WARRANTY BULLETIN

CAN-AM® ROADSTER

Campaign no.: 2014-0010

Subject: **A - Fast Flasher Blink Rate**

1. Key held in vise

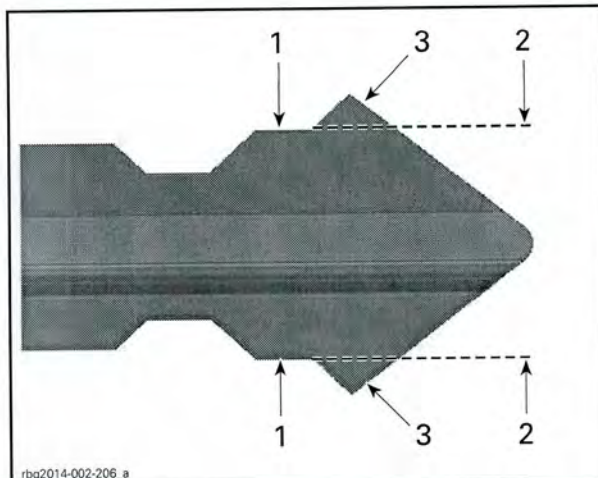
1. Secure ignition key in a vise as illustrated.

NOTE: To prevent vise jaw marks on the key, wrap a clean shop rag around the end of the key to be held in the vise.

NOTICE Do not overly tighten vise or damage to the key will occur.

1. Reference flat surface
2. Cut line
3. Material to remove

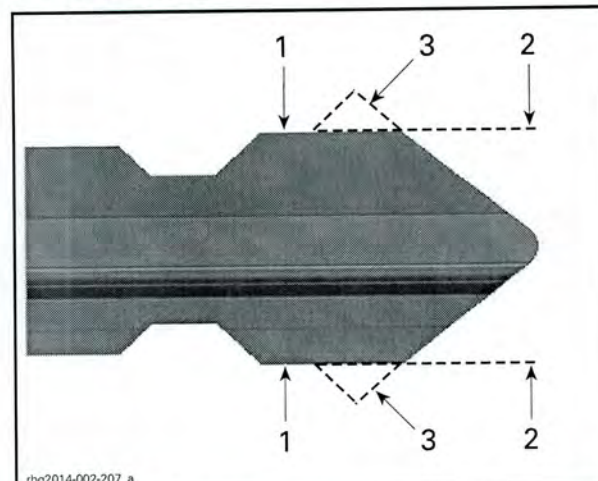
2. Using a small rotary tool, grind off the last point on both sides of the end of the key.

NOTE: The height of the last flat surface will vary with the key code. The modified surface must be in line with and square to the last flat surface of the key.

1. Reference flat surface
2. Cut line
3. Material removed
